STIFFENER
ASCENT STAGE-IMU CABIN BEAM

GRUMMAN AIRCRAFT ENGINEERING CORP.
CODE IDENT NO. 26512
ENGINEERING ORDER

DWG. NO. LDW280-10221 | ED NO. B1
CONTROL INFO NO. LDW280-5745

DRAWING TITLE: FRAME - ASCENT STAGE - CABIN - UPPER - #255375

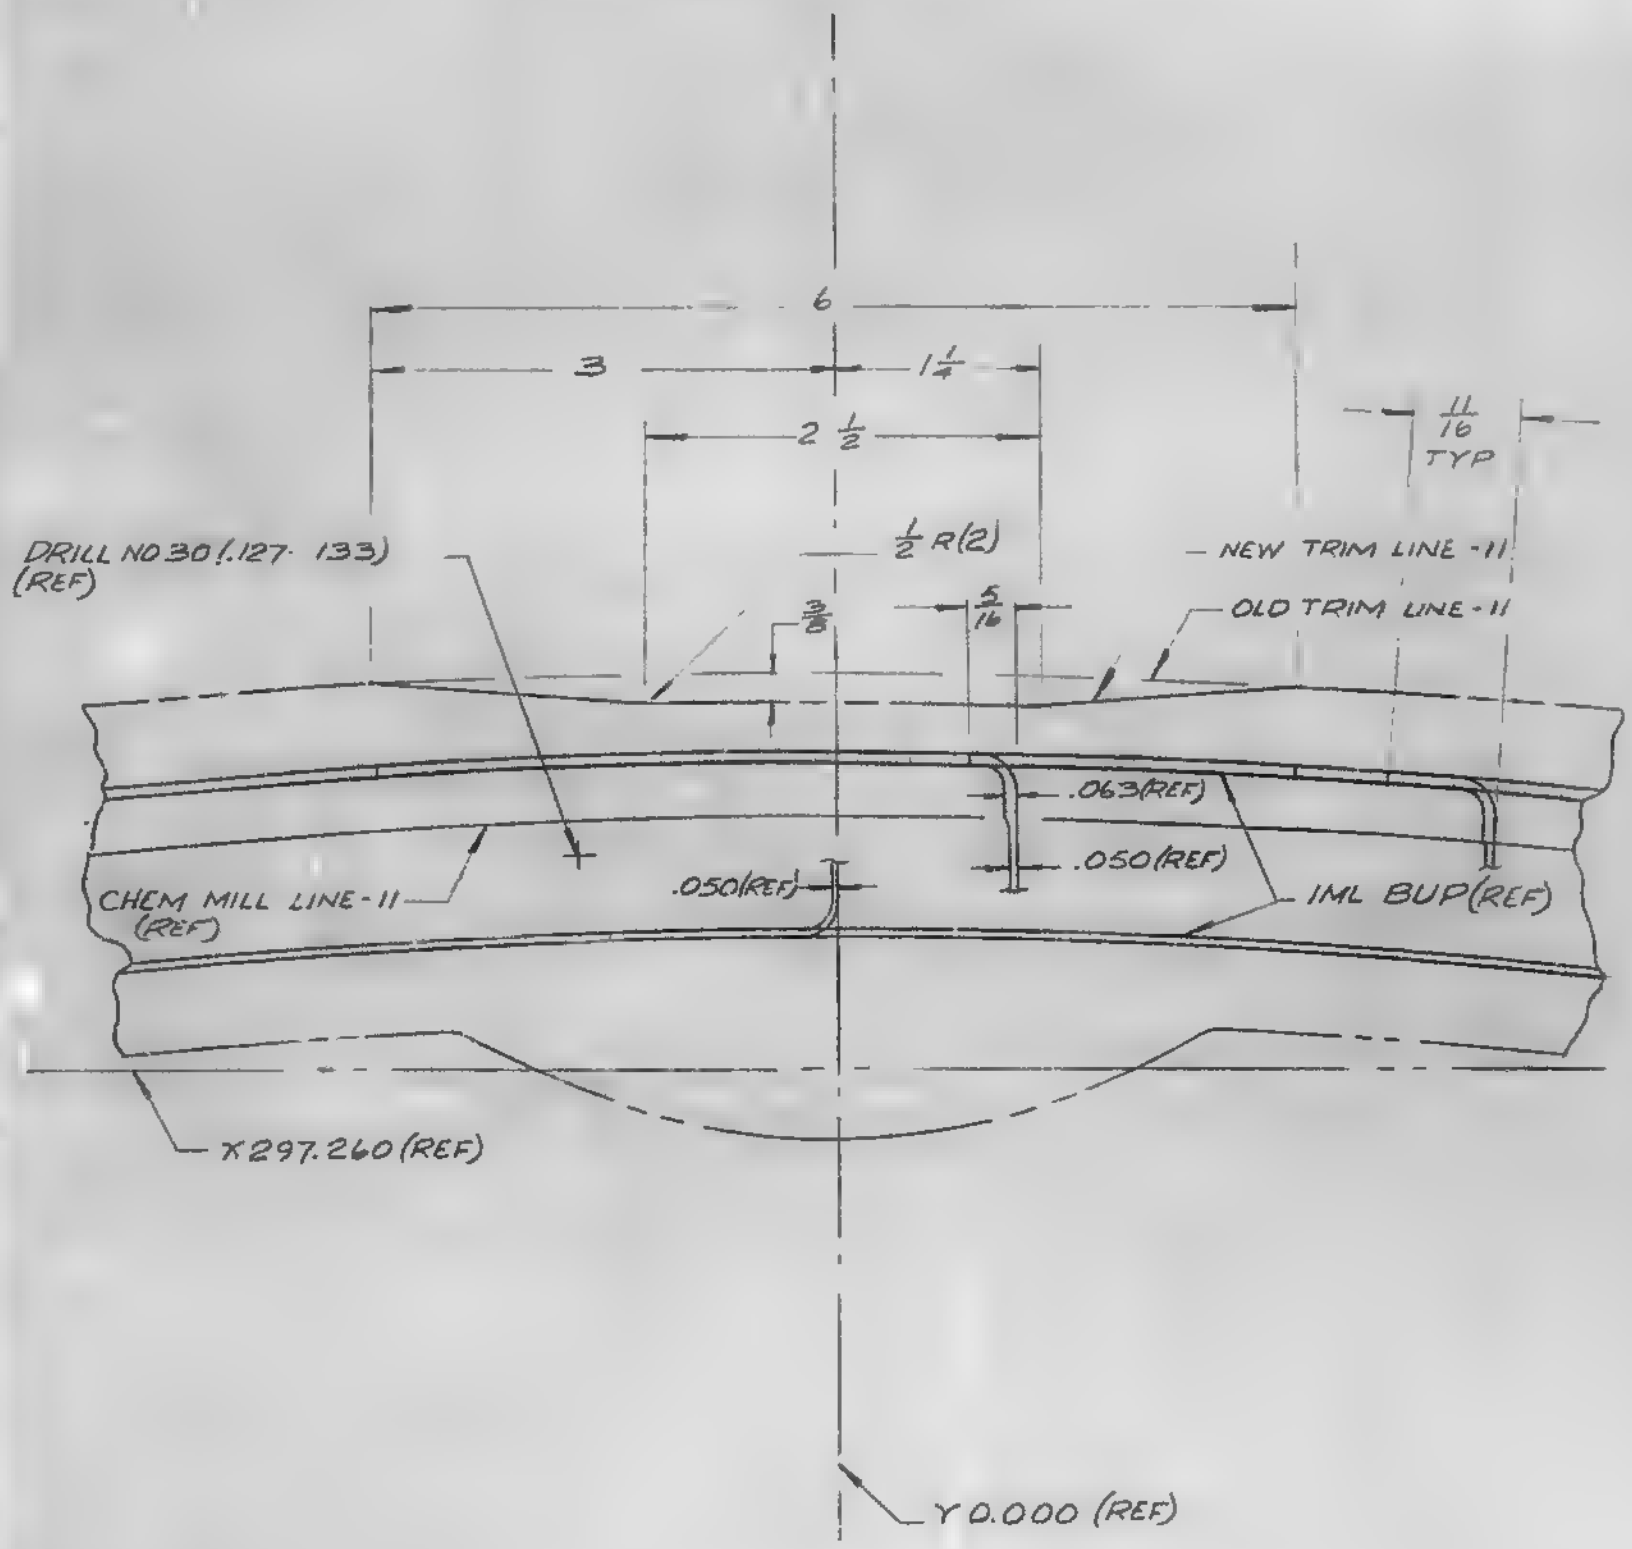
REASON FOR ED: POSSIBLE INTERFERENCE FIT WITH IMU STRUCTURE

DESCRIPTION OF ED: REVISED TRIM LINE OF -11

6
3
1 1/4
2 1/2
11/16 TYP
1/2 R(2)
DRILL NO30 (.127-.133) (REF)
3/8
5/16
NEW TRIM LINE -11
OLD TRIM LINE -11
.063(REF)
.050(REF)
.050(REF)
CHEM MILL LINE -11 (REF)
IML BUP (REF)
X297.260 (REF)
Y0.000 (REF)
